Appendix D

Notice of Determination

Project Title: Kern Fan Groundwater Storage Project

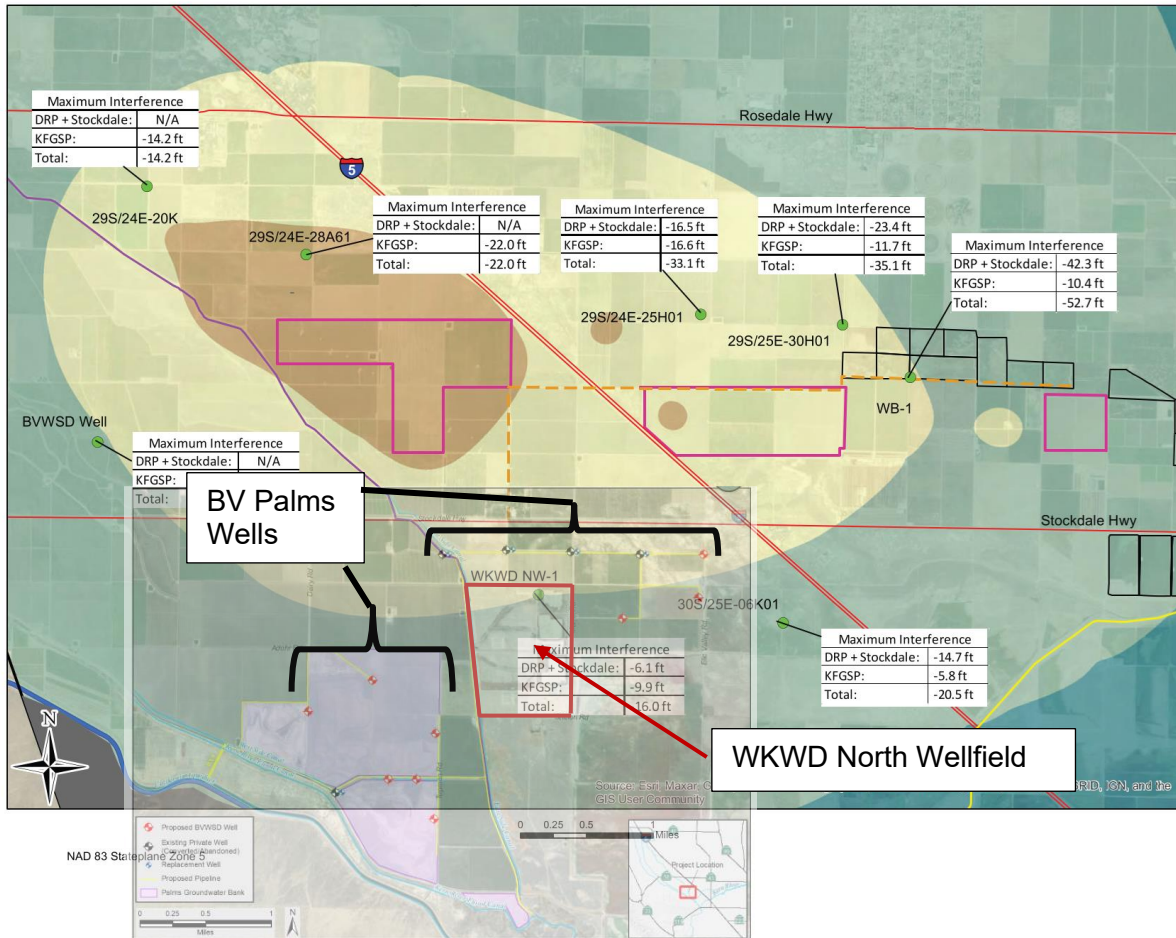
Provided on the next page is an overlay drawing prepared using figures from both the subject Kern Fan Groundwater Storage Project and the BV Palms project. The drawing illustrates the fact that a number of BV Palms extractions wells lie between the WKWD North Wellfield and the Kern Fan Groundwater Storage Project. If extraction is occurring in the BV Palms project at the same time extractions are occurring at the Kern Fan Groundwater Storage Project, at the Drought Relief Project (DRP) and at Stockdale the Integrated Banking Project, the impacts to WKWD North Wellfield wells could be greater than anticipated by the modeling.

Figure 1

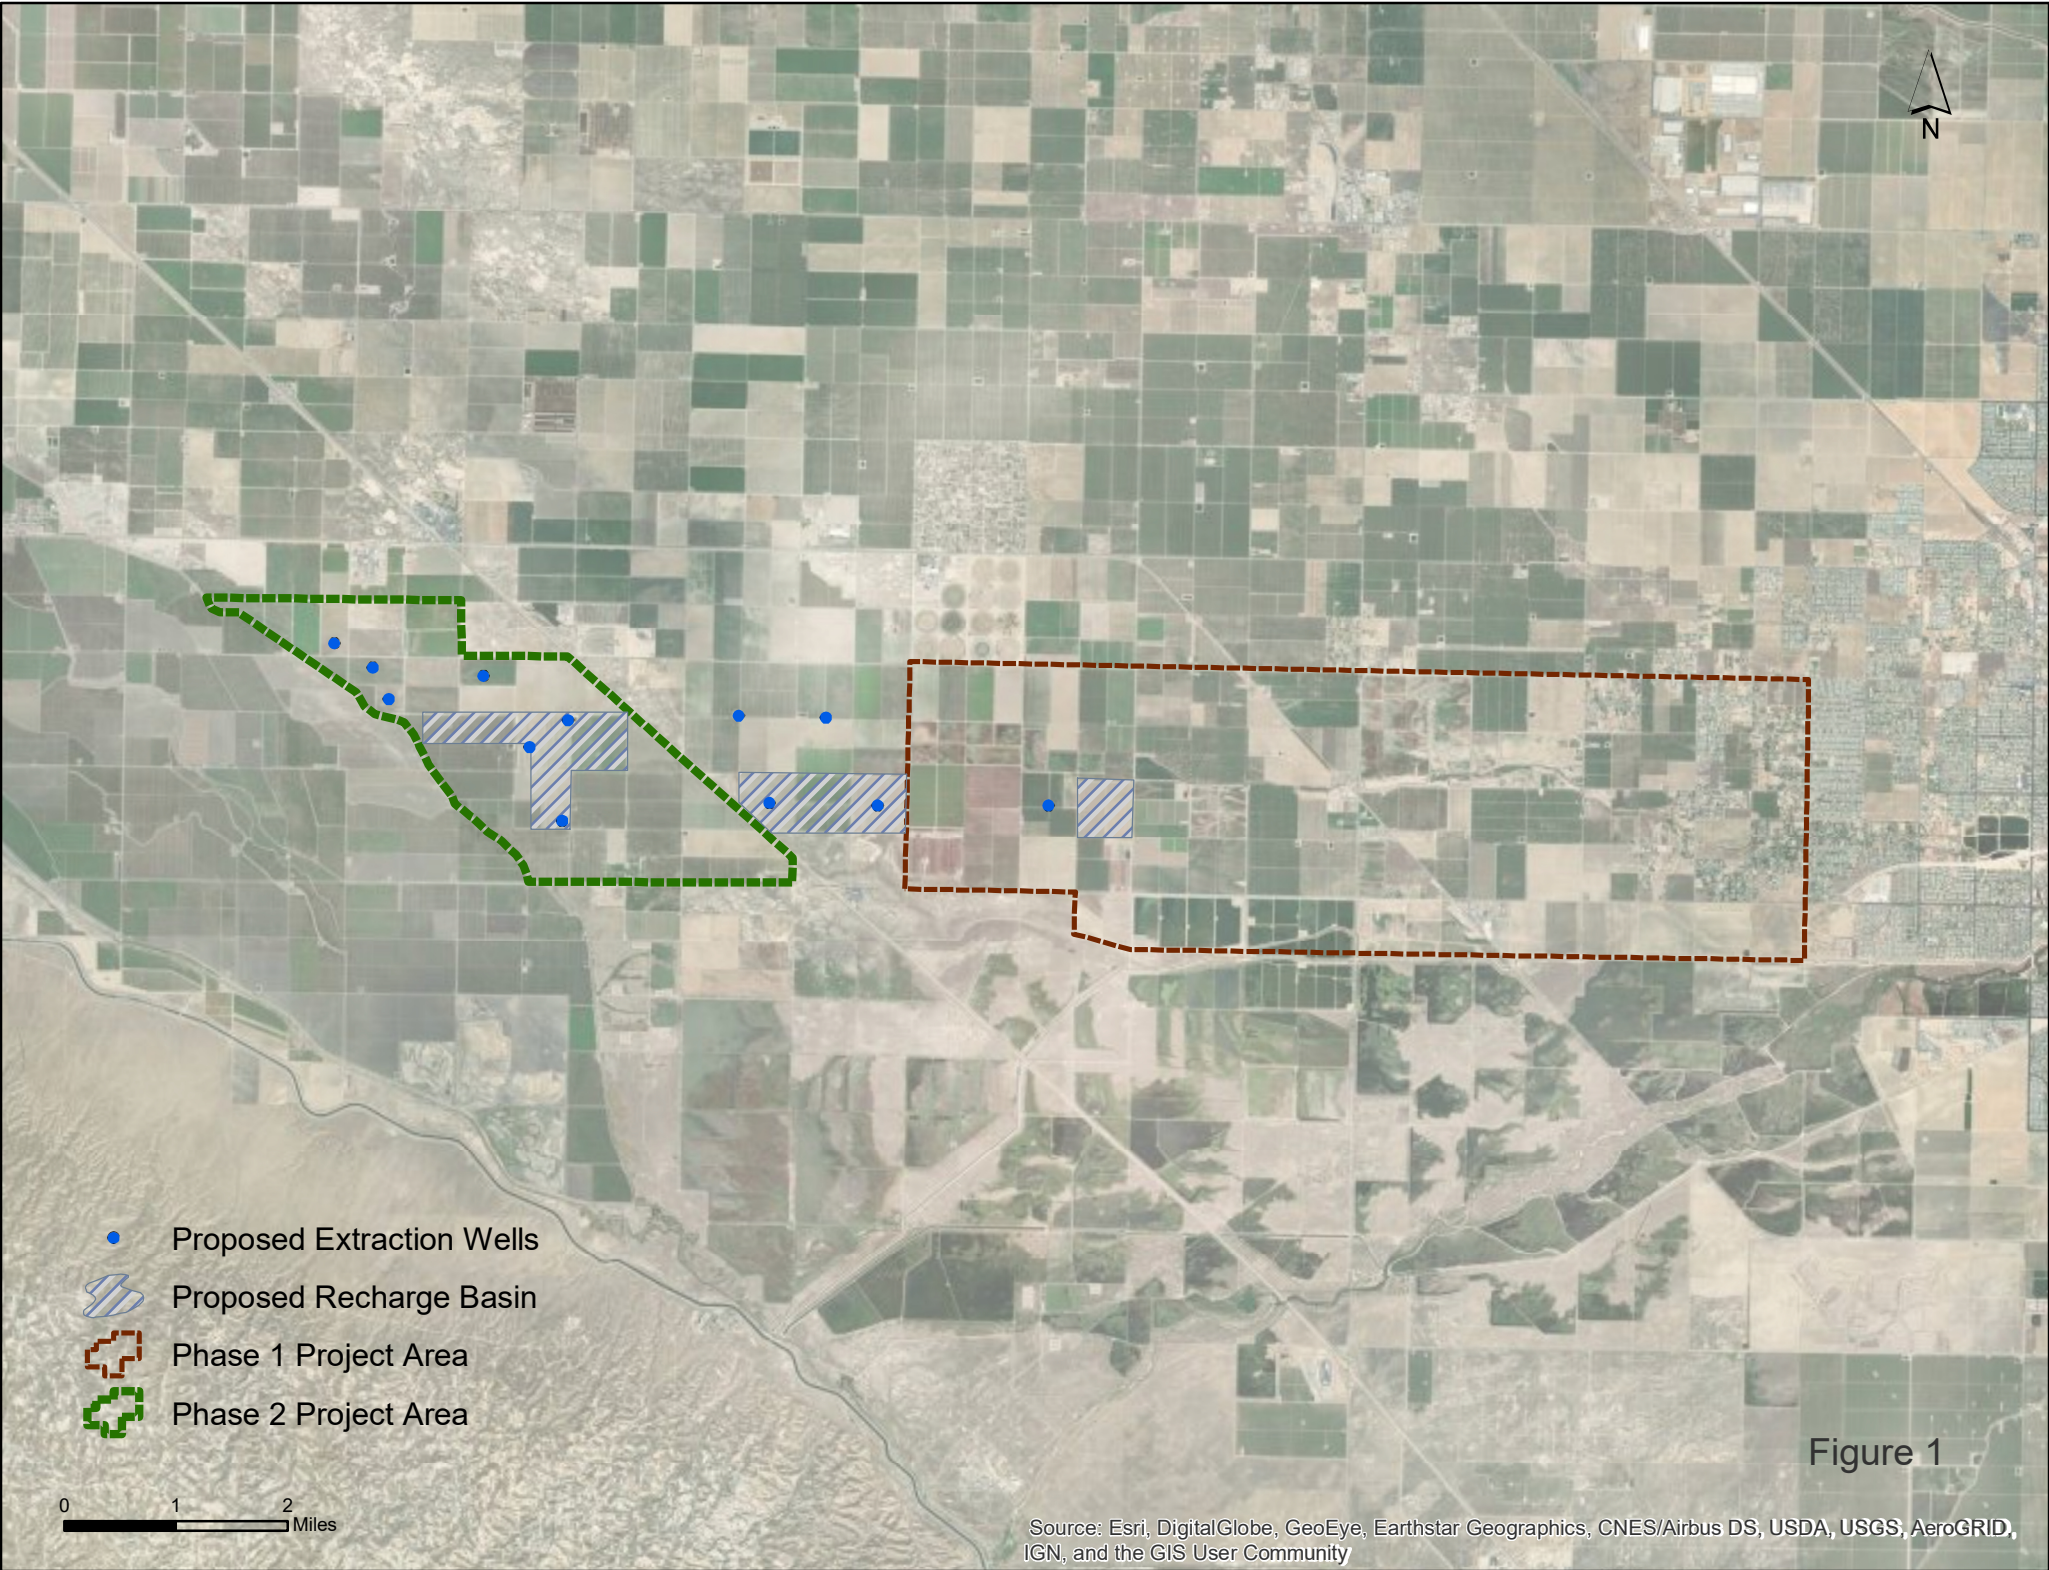
As noted above, the DEIR does not clearly describe the specific locations for Project conveyance facilities, and does not even propose a specific alternative for Project conveyance facilities as required by CEQA case law. The DEIR does not describe or analyze in any meaningful detail the effects of alternative locations of conveyance facilities. A detailed analysis of the effects of the alternative conveyance facility locations is particularly important here because of the DEIR's acknowledgement of the potential impact of the conveyance facilities on the Kern Water Bank and on other water supply facilities. The Kern Water Bank is subject to the requirements of the Kern Water Bank Habitat Conservation Plan/Natural Community Conservation Plan ("Kern Water Bank HCP/NCCP"). The location of the Project conveyance facilities on the Kern Water Bank land will likely adversely impact the biological resources of the Kern Water Bank, and interfere with the Kern Water Bank Authority's achievement of the biological objectives of the Kern Water Bank HCP/NCCP.

Kern Fan Groundwater Storage Project
Figure 2-1 Revised
 Regional Project Location

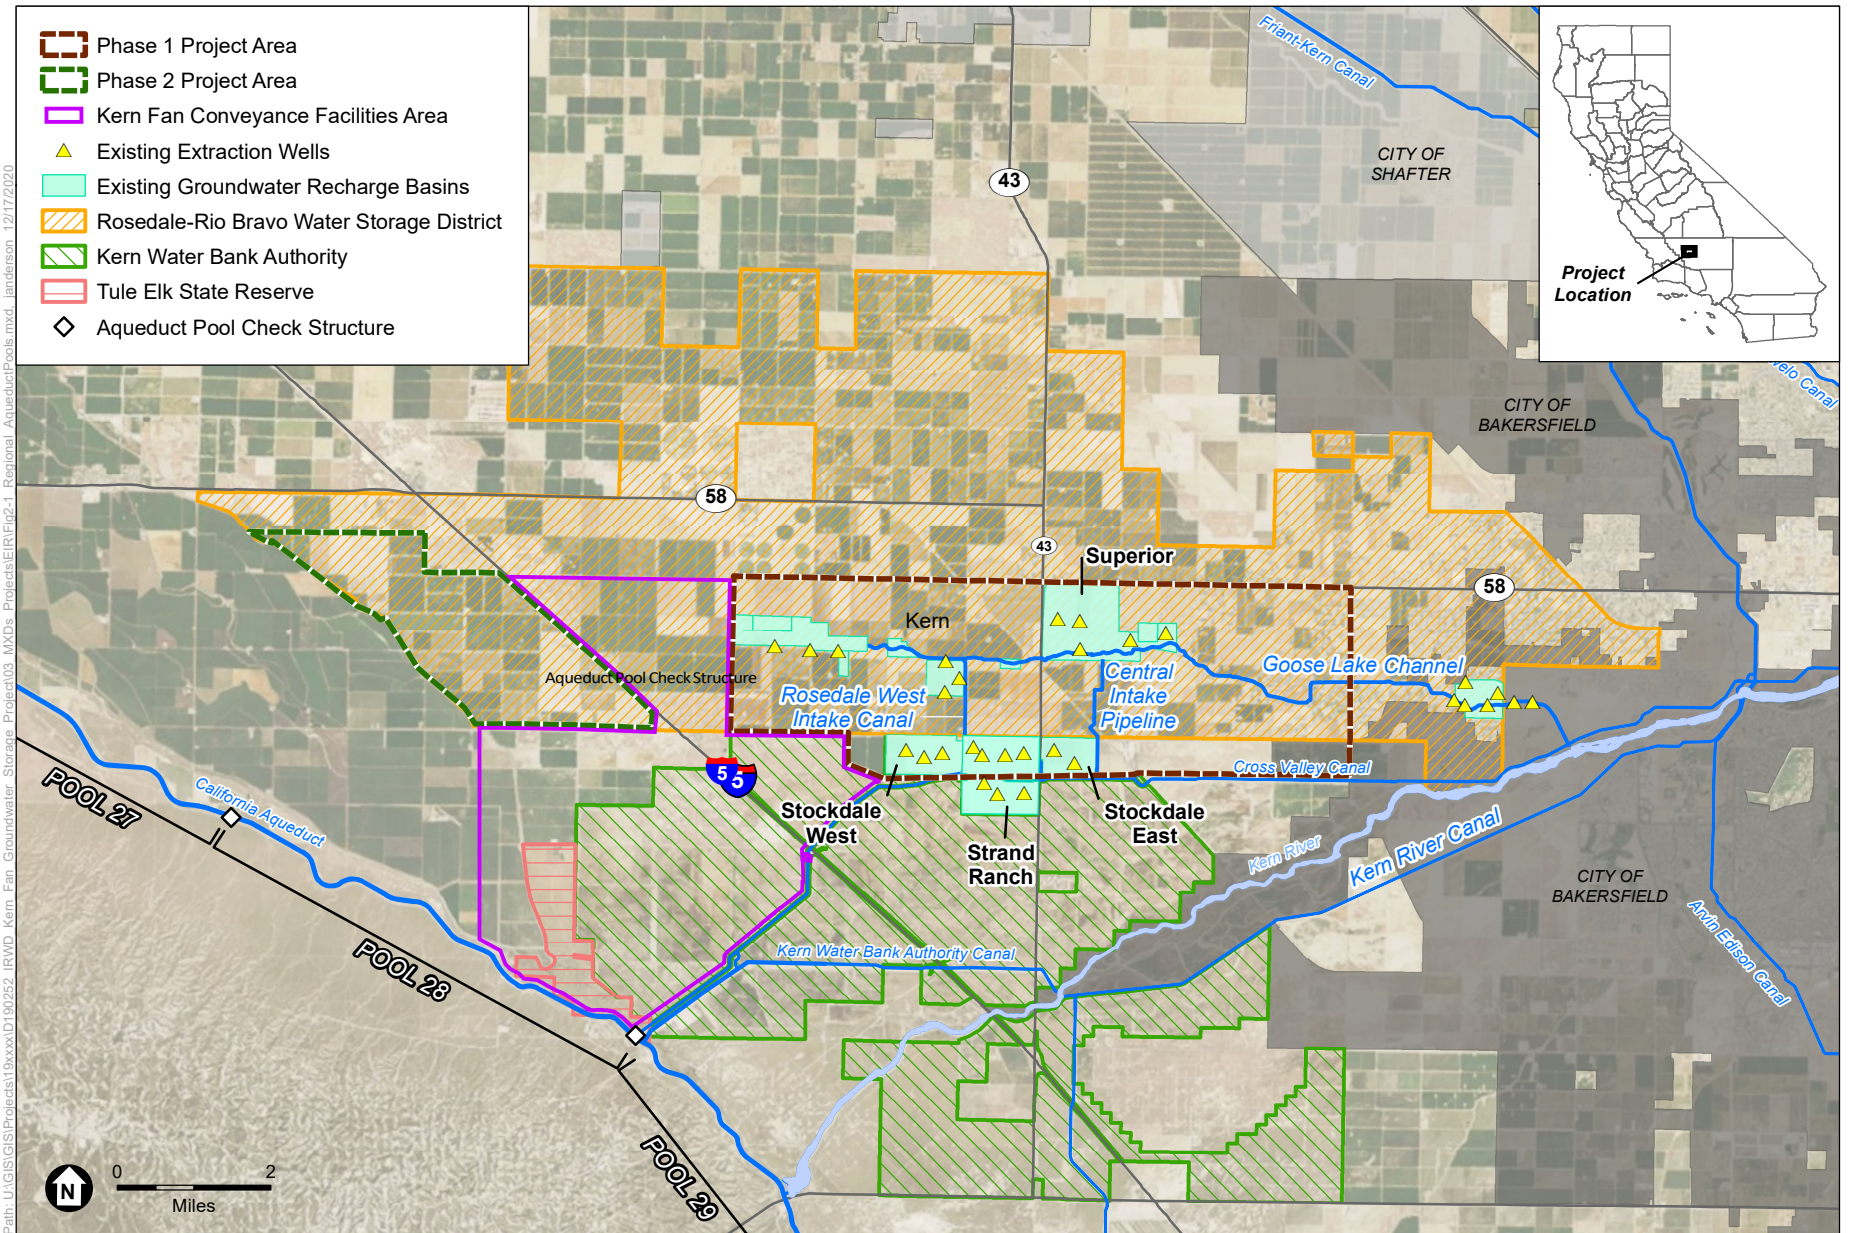
The comment states that the Draft EIR’s Project Description includes insufficient information on construction of the turnout at the California Aqueduct. The comment then states that the construction schedule does not consider potential impacts of ongoing or simultaneous construction activities in the vicinity involving the maintenance of the Aqueduct. The comment states that the Draft EIR does not provide a reasonably specific location of where the turnout would be placed, nor does the analysis of construction activities adequately address potential impacts to the Aqueduct and other SWP facilities.

The analysis of potential environmental impacts in the Draft EIR are based on the location of the proposed turnout within Pool 28 of the California Aqueduct. In response to the comment, the text of the Draft EIR on page 2-6 is revised as follows:

In addition, in response to the comment, Figure 2-1 of the Draft EIR is revised to show the location of Pool 28 of the California Aqueduct, which is directly adjacent to the area identified for the Kern Fan Conveyance Facilities, of which the proposed turnout would be a component.
